NONCONFORMANCE - REPORT LOG & STATUS BOOK

1. PROJECT NO. 7220

1. Project Name Midland Units 1 and 2		Job No. 7220		19. No. 586	20. Page 1 of 25		
2. Unit(s) 2	3. Drawing/Part No. M-613 sh 1	Rev 3/F2	4. Item Description Nuclear Class 2 Pipe spool 2-GCB-006-S613-7	5. Item Location Containment Dome Unit 2

BASE MATERIAL REPAIR  
MAP  
FOR  
PIPE SPOOL 2-GCB-006-S613-7

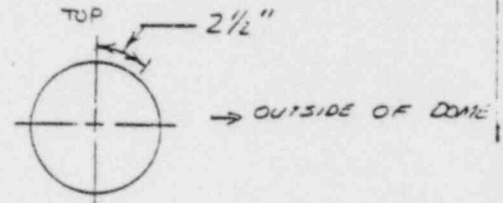
DEFECT # 1

SUBJECT CCW PUMPS EL. 584'-0" AS BUILT \* OF CUT BARS

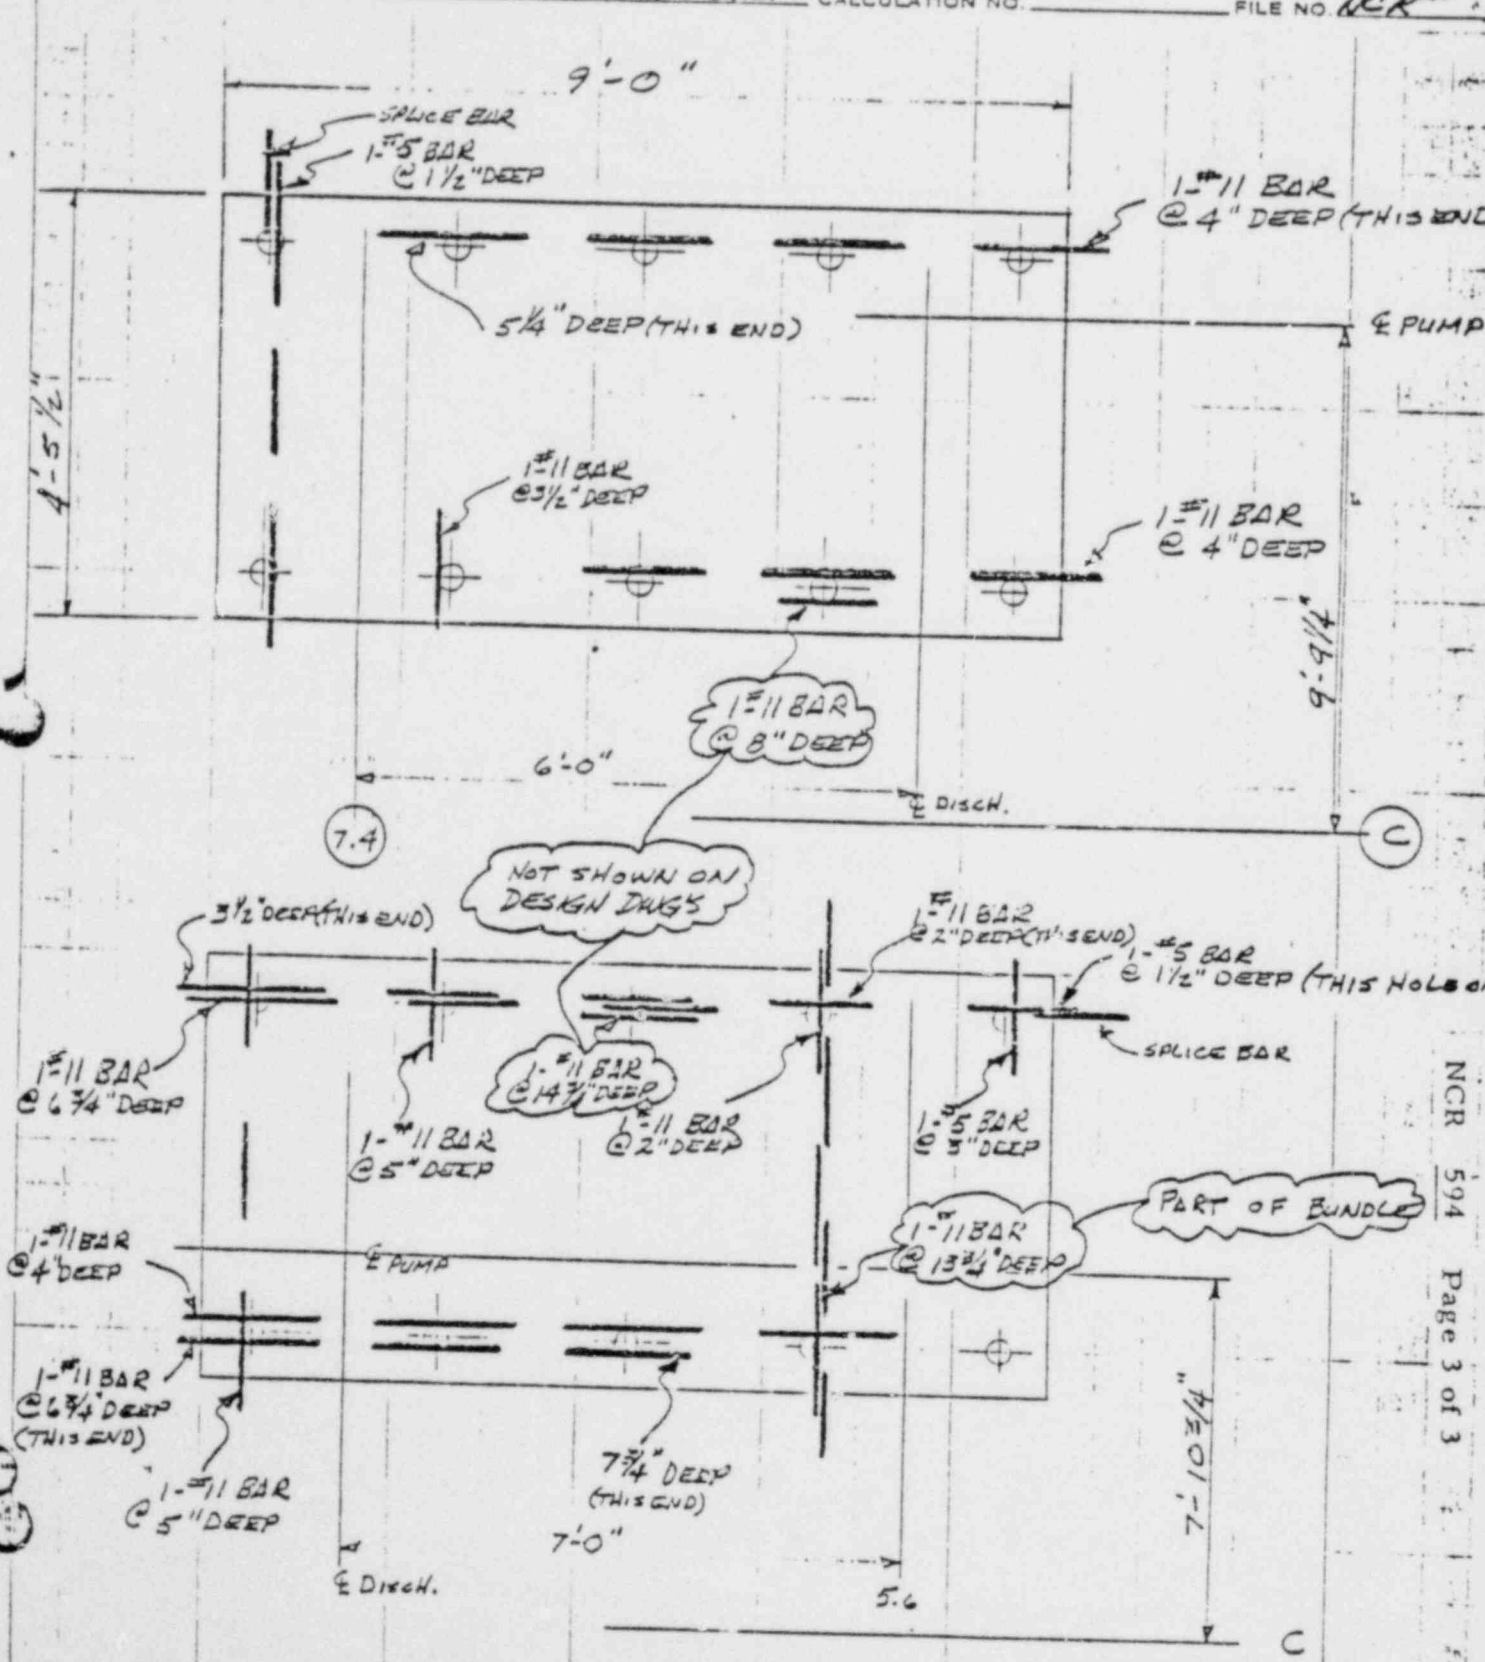
16. Nonconforming Condition: Note number six (6), on drawing C-184 (Q) Rev. 2, states that "Where drilled anchor bolts are used for equipment foundations, 10% of the number of reinforcing bars in an active section in any direction may be cut U.N.O." Contrary to this, when drilling for anchor bolt holes at the CCW pump pads, shown on drawing C-195 (Q) - 4, this limitation was exceeded. The number of bars allowed to be cut per note 6 on drawing C-184 is:				15. Equip Furnished By <input type="checkbox"/> CLIENT <input type="checkbox"/> ENG <input checked="" type="checkbox"/> FLD

PLAN @ EL. 584.0

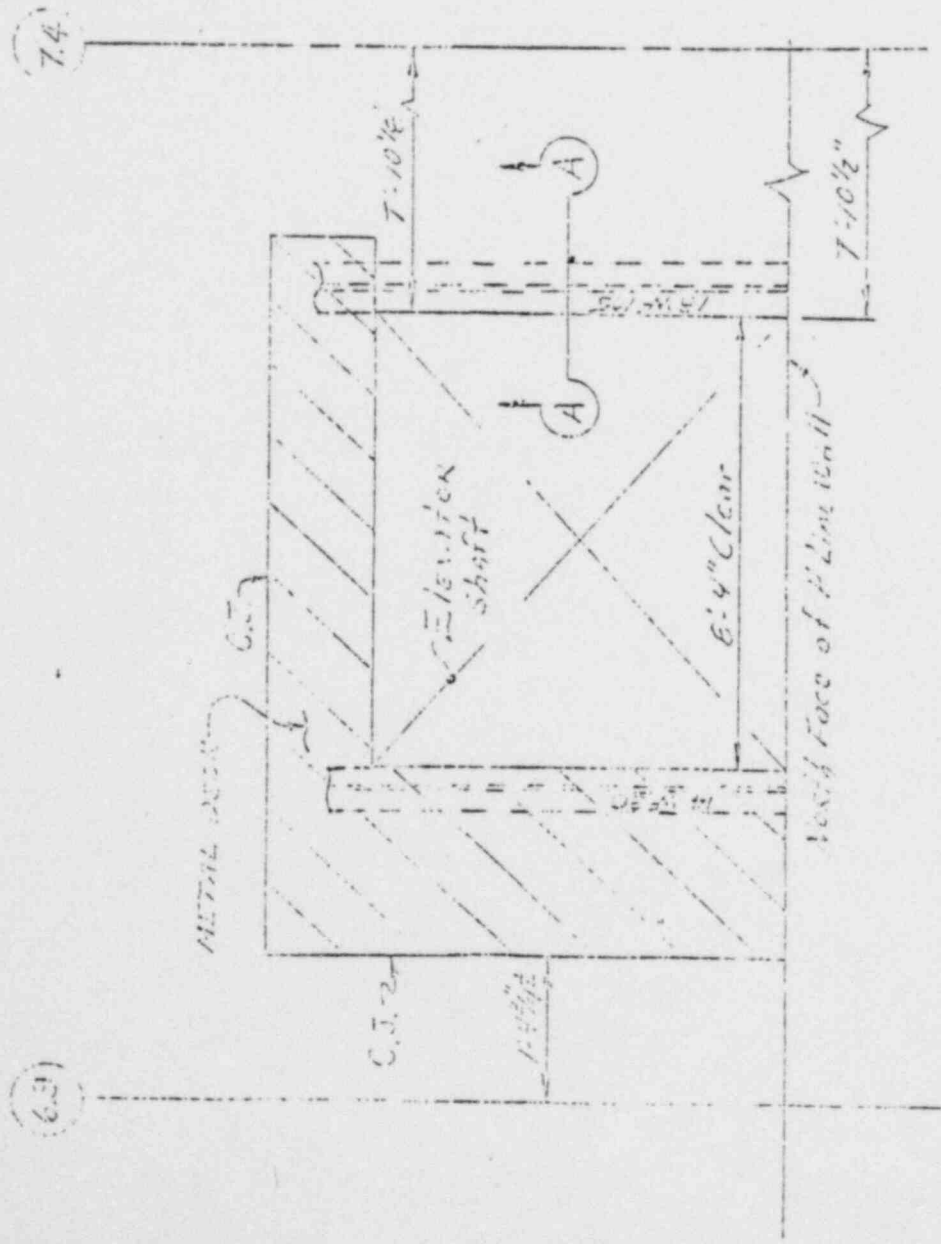
16. Nonconforming Condition: The attached sketch shows the El. 584'0" elevator shaft as-built condition which does not conform to the dimensions called out on drawing 7220-C-202 Revision 6. 1 Hold Tag Applied. Q-List No. 1.00. Hold for Engineering Disposition.				24. Disposition Concurrence			
				REWORK	REJECT	REPAIR	USE AS IS
				PROJECT FIELD ENGINEER	DATE		
				PROJECT ENGINEER	DATE		
				PROJECT CONSTR 3C ENGINEER	DATE		
				AUTHORIZED INSPECTOR	DATE

ASME HANGER # 16-HBC-134-H1

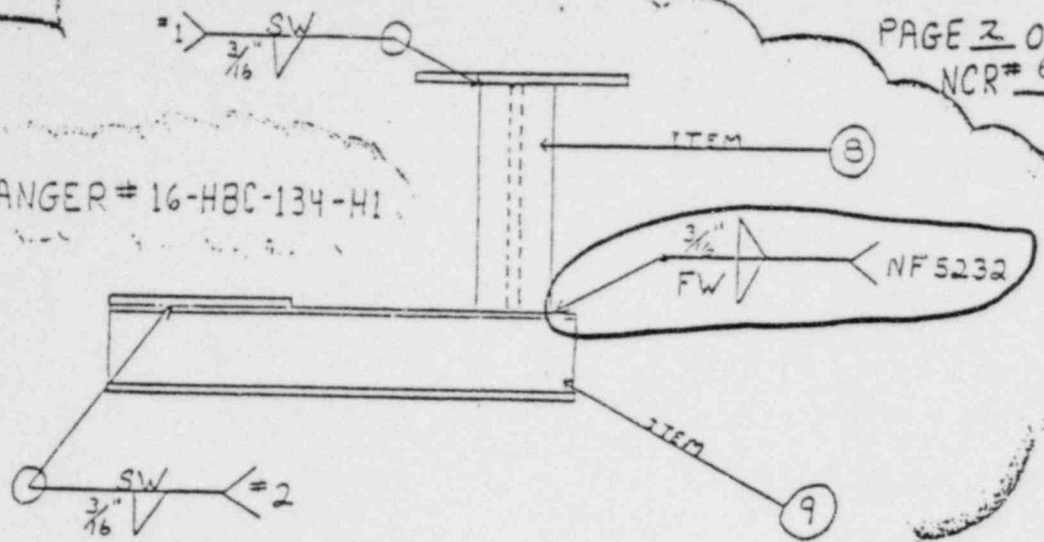
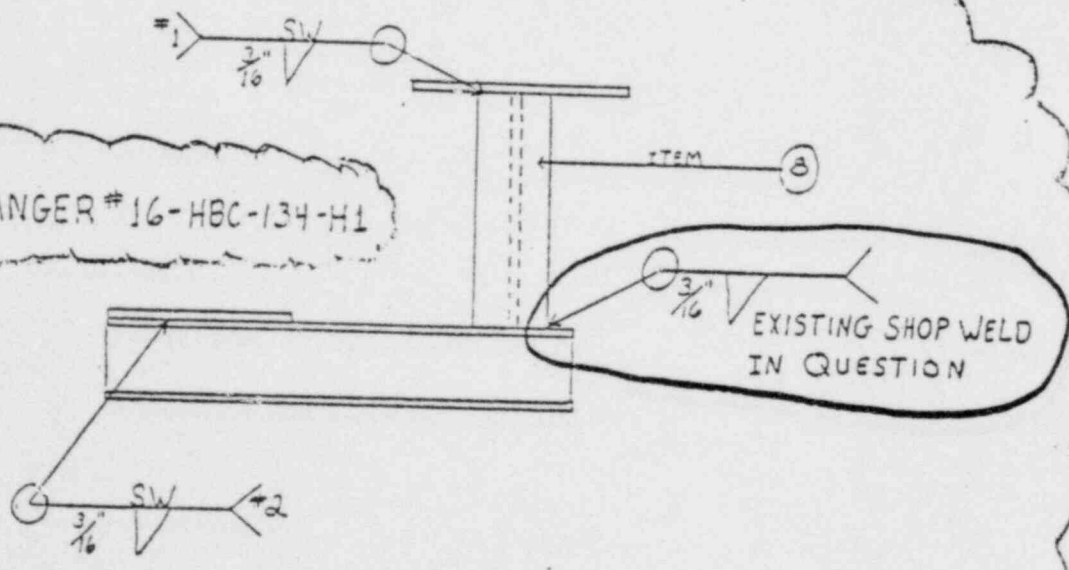
DETAIL: AS PER SECTION AA  
ITT GRINNELL DWG.# 2-617-6-1 Rev. 2  
DESIGN AS SHOWN

AS BUILT

5.6 LINE WALL, WEST FACE (LOOKING EAST)

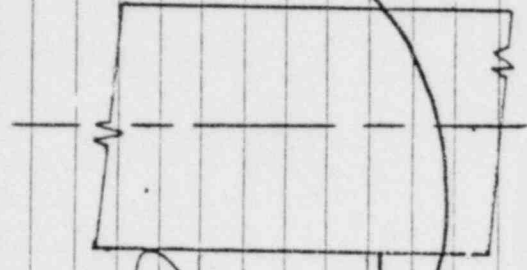
26 OF 31 DOWELS HAVE FROM 1/4" TO 0" COVER  
TOL. ER. 0.24'-0"

3"-2FCB-28-H6

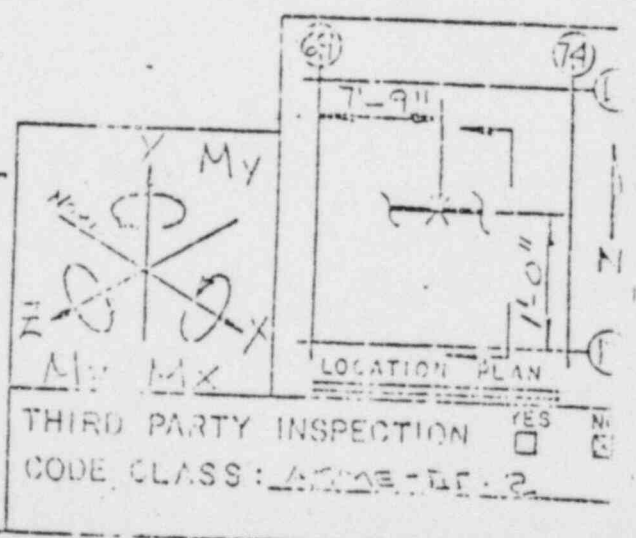
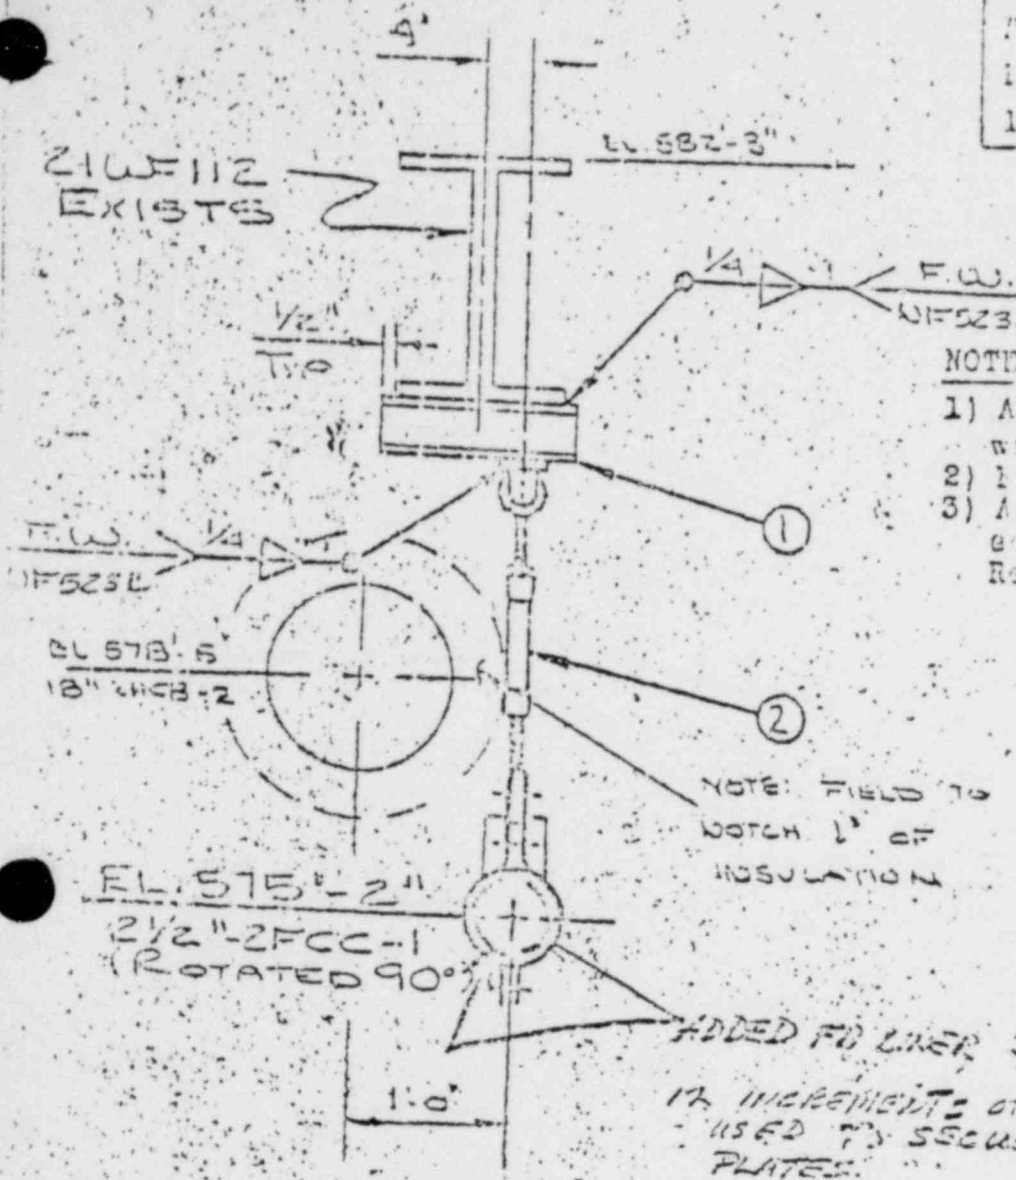
DESIGN SK 2-11-4-34 REV 1  
 VENDOR DRAWING REVIEW APPROVAL  
 LEVEL 1  
 S. AMP 82476  
 CLAMPS USED ARE MODIFIED 3" DIA  
 FIG. 295 WITH FLAT BAR LINERS  
 SKETCH INDICATES 3" DIA FIG 295  
 FOR USE ON BILL OF MATERIALS  
 ITEM 3, FIG. 211. 1 SWAY STRUT

3-2FCB-28-H4

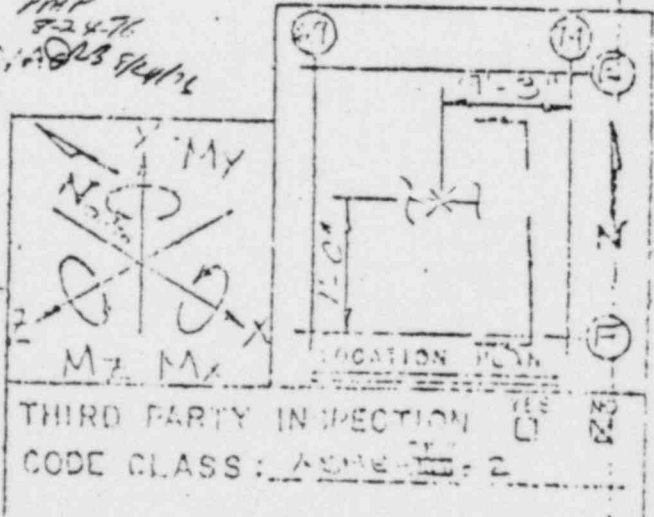
CLAMPS USED ARE MODIFIED 5" <sup>PMP 82476</sup> <sub>3/8" DIA</sub> <sup>3/8" DIA</sup> <sub>3/8" DIA</sub>  
FIG 295 WITH FLAT BAR LINERS.

fig. 211

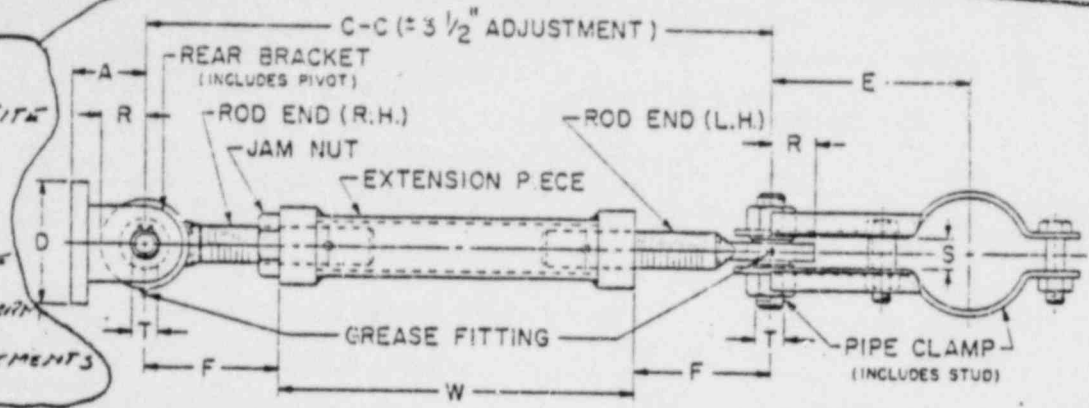
delivered were Figure 211 clamps with flat bar liners welded inside the clamp to conform with O. D. requirements of the applicable sketch. See attachment A.

DELIVERED TO JOBSITE  
FIGURE 211 CLAMP  
WITH FLAT BAR  
LINER WELDED INSIDE  
THE CLAMP TO CONFORM  
TO THE O.D. REQUIREMENTS

Block 16 continued.

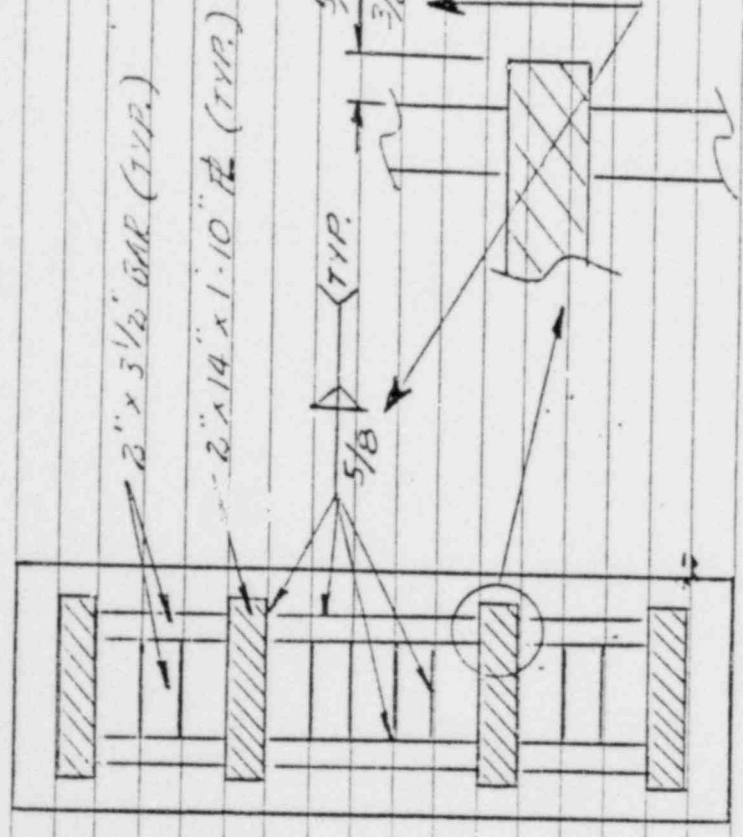
16. Nonconforming Condition: 1. Bechtel approved Mississippi Valley Structural Steel drawing F-7220-C233A-13614-MV-6-3 requires 5/8" fillet welds for some joints at type P14 Embeds. Contrary to the above, various welds on eleven type P14 Embeds were found to have insufficient leg and/or throat dimensions. See attached sketch for locations of joints requiring 5/8" fillet welds.			24. Disposition Concurrence			
			REWORK	REJECT	REPAIR	USE AS IS
			W.C. Bosworth Talonys 10/18/76 PROJECT FIELD ENGINEER DATE J. Hinkley RLC 10/13/76 PROJECT ENGINEER DATE M. D. Forten 10/19/76 PROJECT CONSTR QC ENGINEER DATE AUTHORIZED INSPECTOR DATE

5/8 REQ'D  
3/8 TO 1/2 ACTUAL
